ADDENDUM NO. 1

Date: 22 May 2020

Project No.: 1918

Project Name: Tourism Office Renovation

MODIFIED DATE:	JOB NO: 1918
ISSUED DATE: FOR PRICING 24 APR 2020	SHEET: SD-2

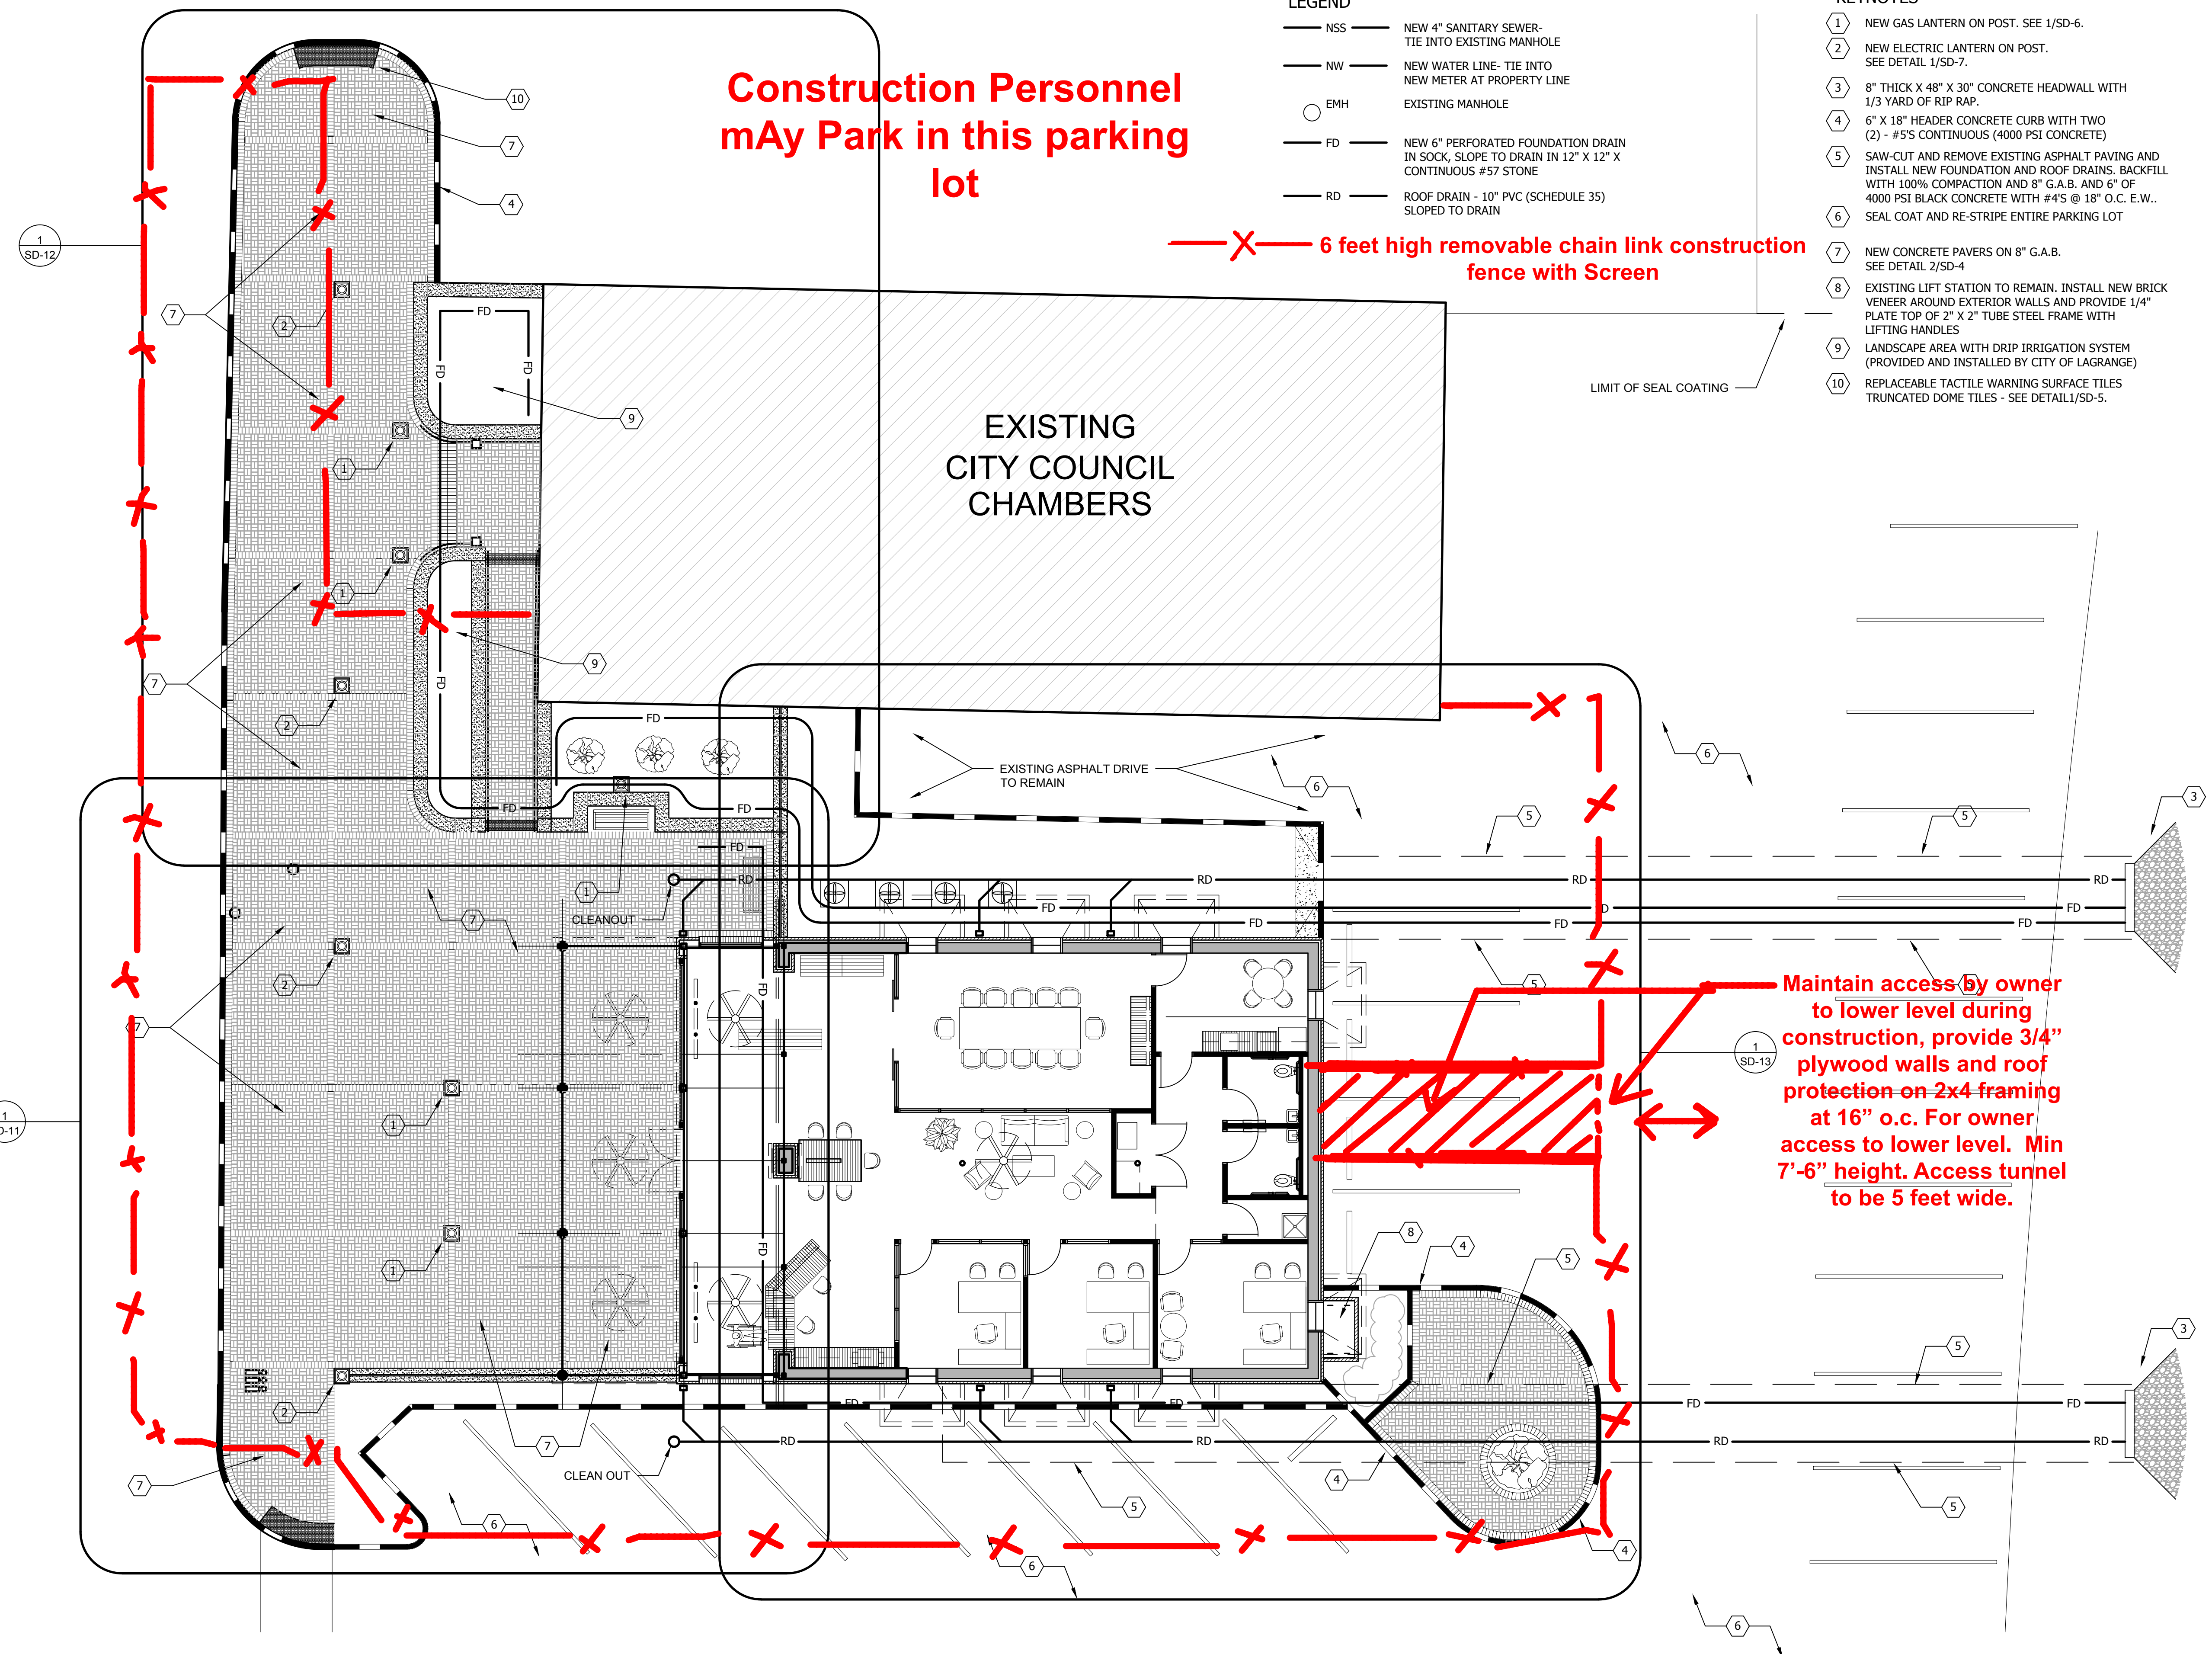
- A. Remove "NSS" and "NW" from the legend; they are not used.

1.03 SHEET SD-2, SD-11, SD-9

- A. All landscaping area in planters to have all drainage, waterproofing components as detailed on the drawings including clean imported top soil.
- B. All landscaping, irrigation, drip irrigation to be provided and installed by City of LaGrange.

MODIFIED DATE:	JOB NO: 1918
ISSUED DATE: FOR PRICING 24 APR 2020	SHEET: E-1

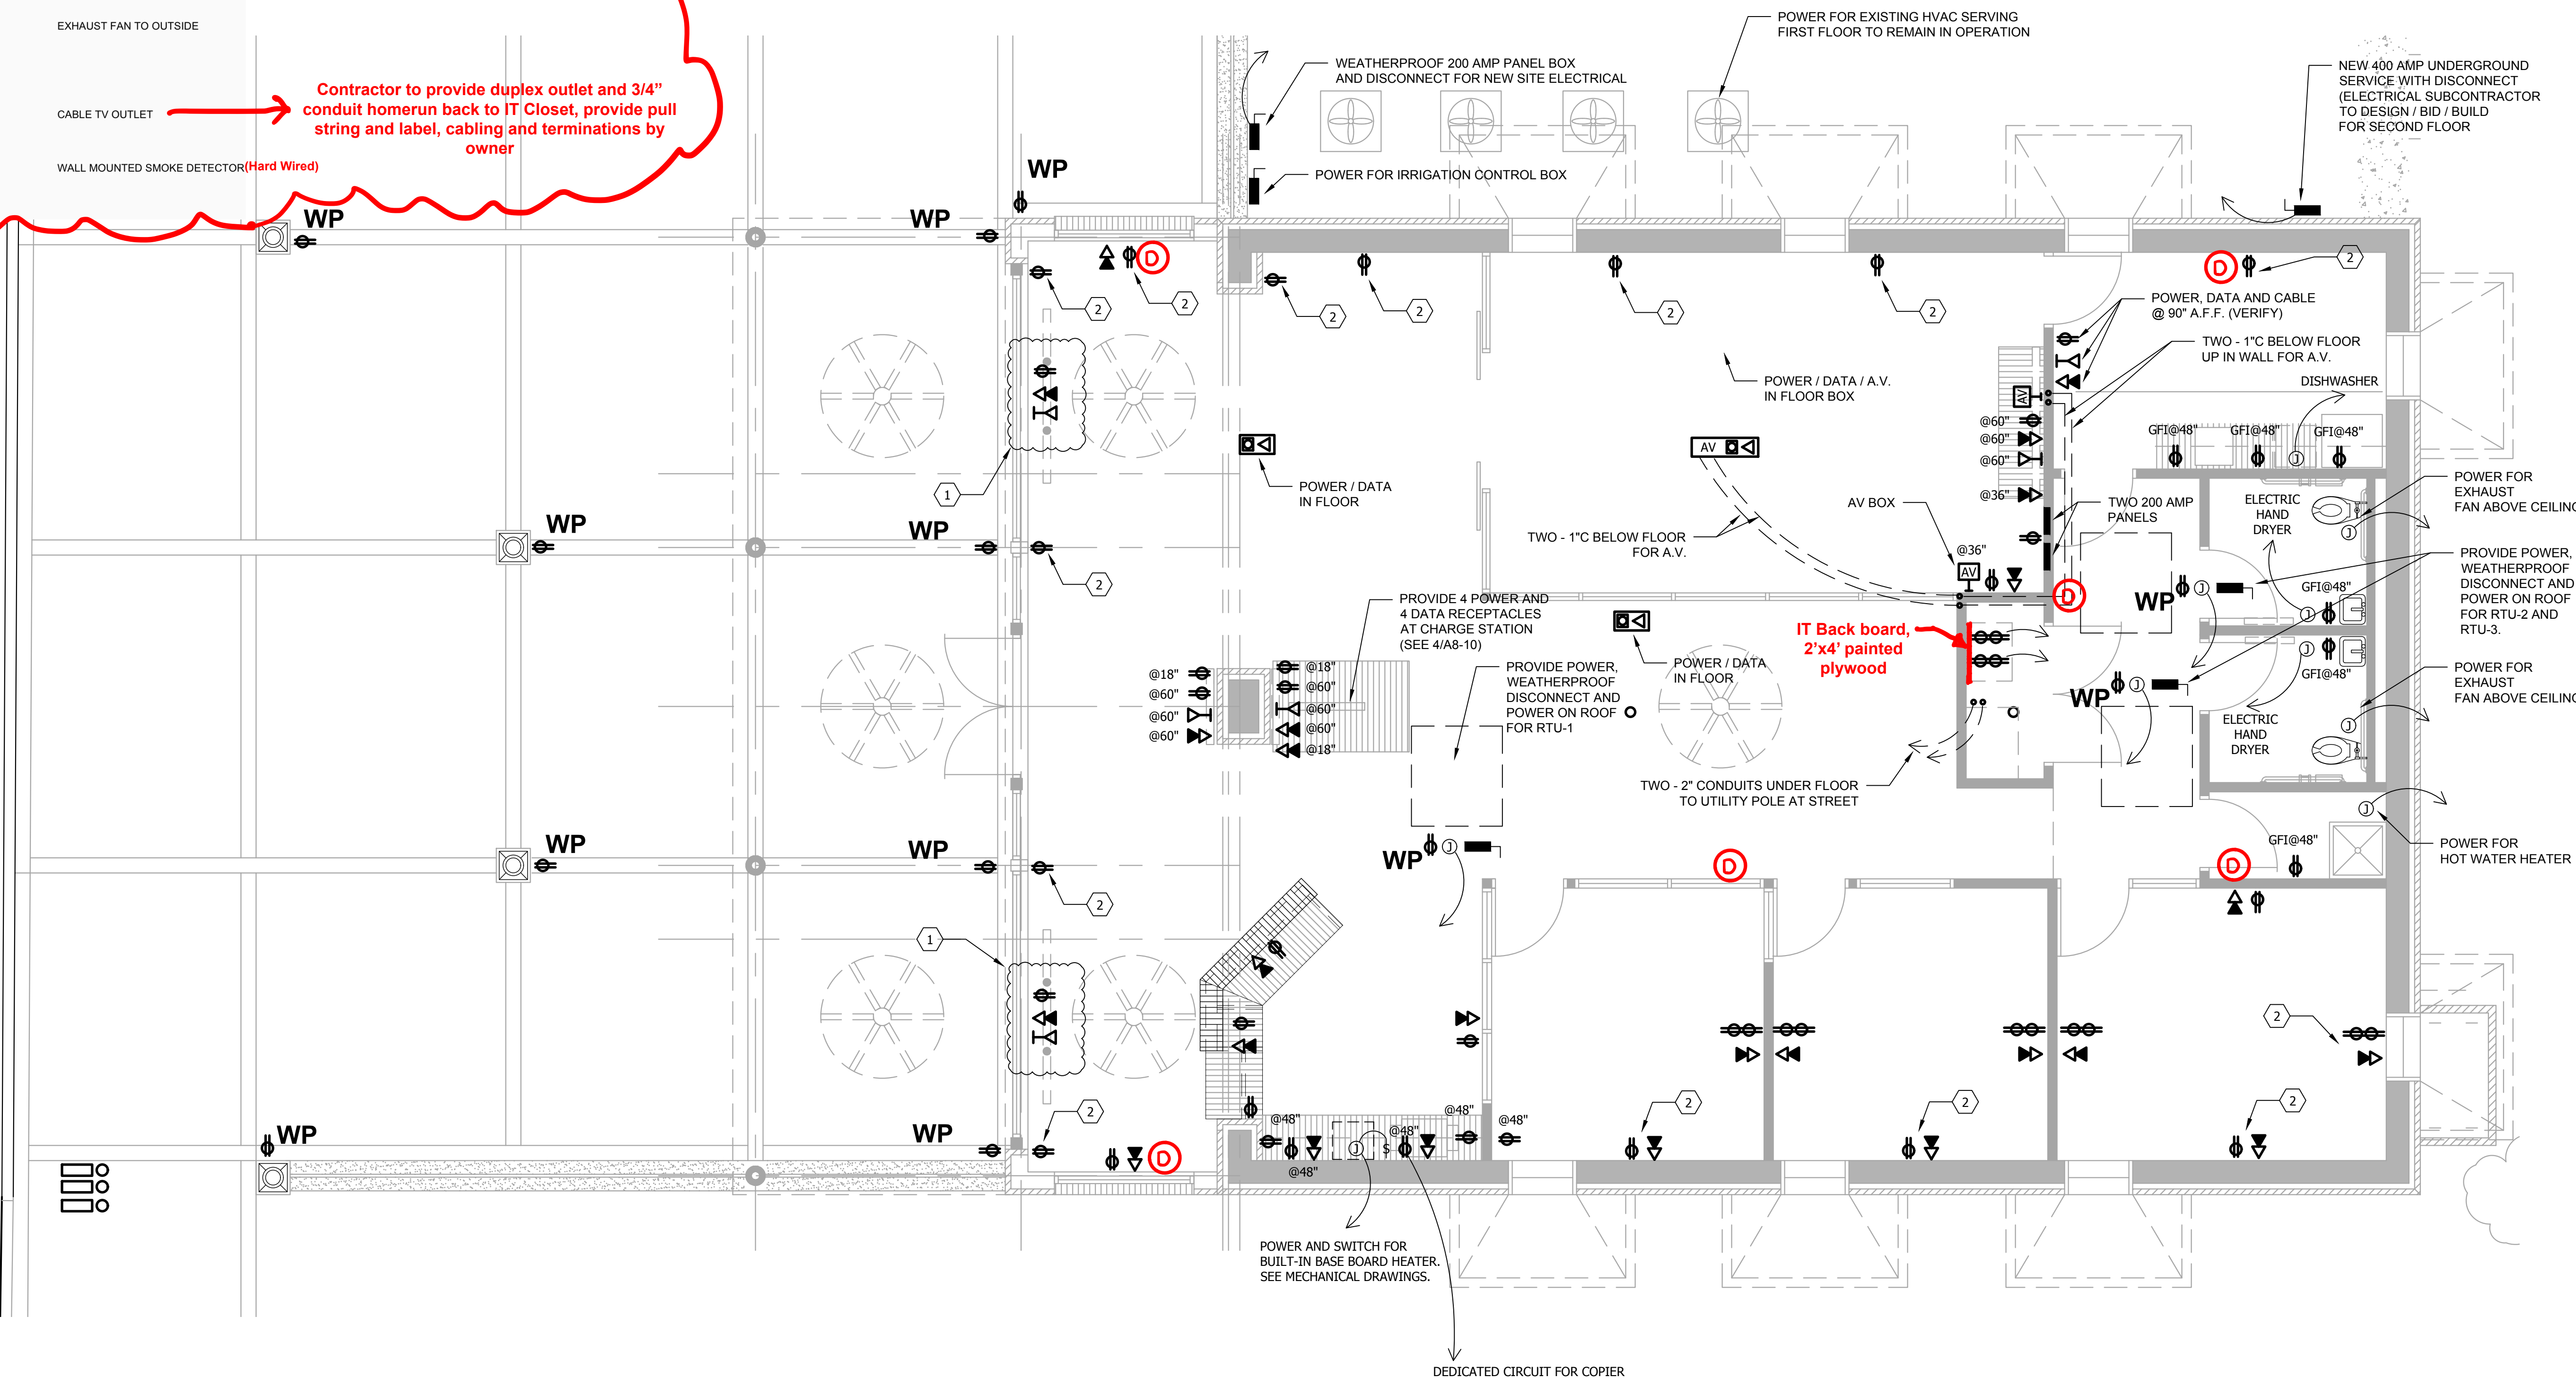
1.18 SHEET E-1

- A. See attached revised Sheet E-1 [ADD1-4A dated 22 May 2020] showing electrical legend for phone, data, power, etc.

- A. Hand dryers are shown in toilets on Sheet E-1.

Contractor to provide duplex outlet and 3/4" conduit homerun back to IT Closet, provide pull string and label, cabling and terminations by owner

ADDED AS PART OF ADDENDUM NO. 1
